## PLUG AND ABANDONMENT PROCEDURE

### Jicarilla 451-09 #131

Re: Permanent Abandonment  
Well: Jicarilla 451-09 #131

CONDITIONS OF APPROVAL

**Jicarilla 451-09 #131**  
**PROPOSED P&A Diagram**  
 API # 30-039-29444  
 NWSW Sec 9, T29N, R3W Rio Arriba, NM

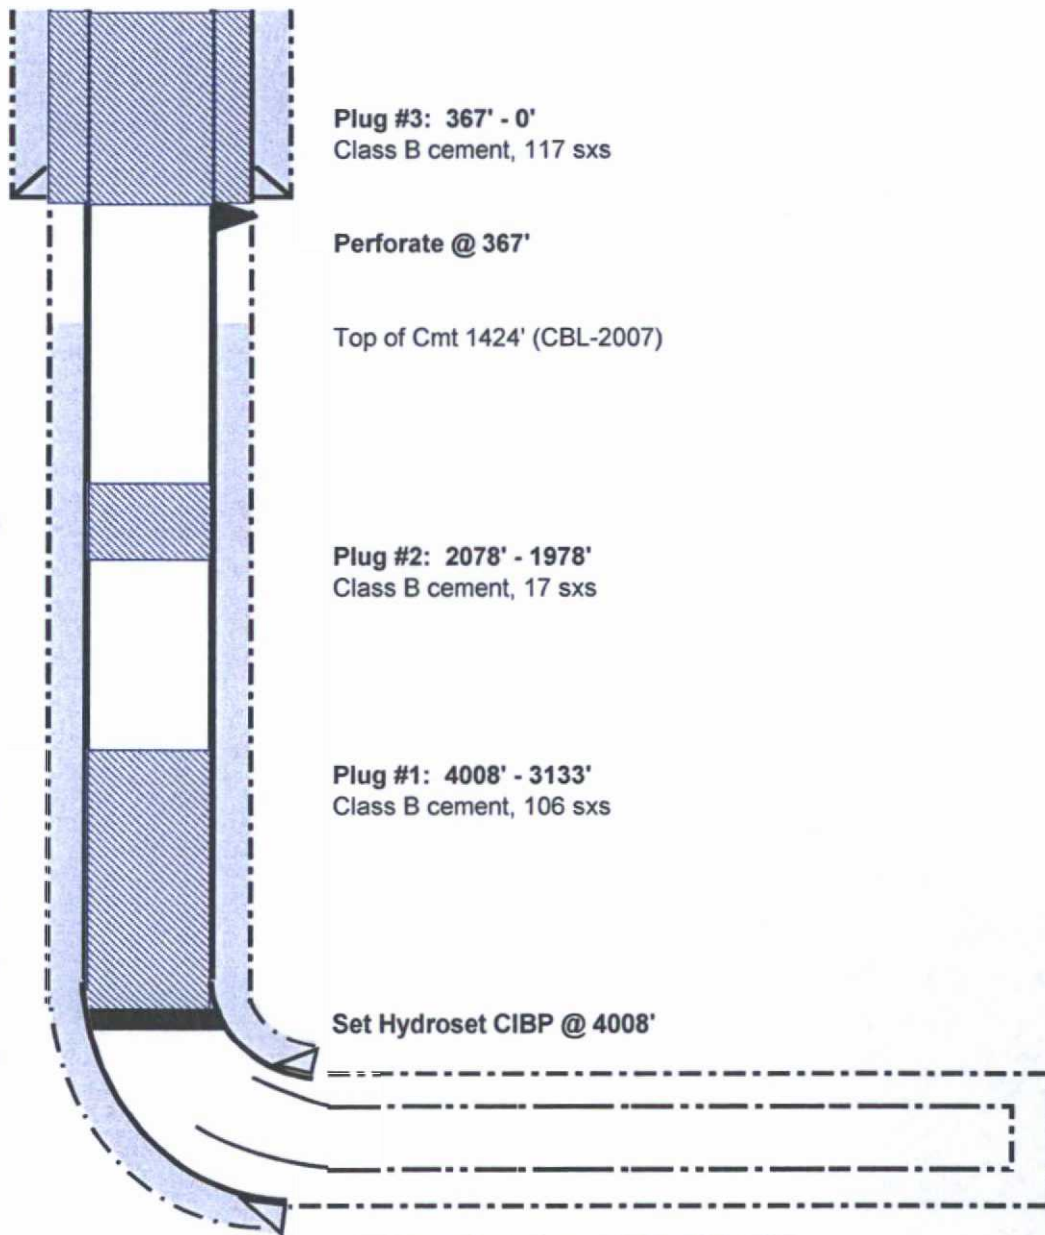
1. Plugging operations authorized are subject to the attached "General Requirements for Permanent Abandonment of Wells on Federal and Indian Lease."
2. Farmington Office is to be notified at least 24 hours before the plugging operations commence (505) 564-7750.
3. The following modifications to your plugging program are to be made:
  - a) Bring the top of plug #2 to **1870 ft.** to cover the Nacmiento top. **BLM picks top of Nacimiento at 1920 ft.** Adjust cement volume accordingly.

**CBL (2007) will suffice for verification of TOC.**

You are also required to place cement excesses per 4.2 and 4.4 of the attached General Requirements.
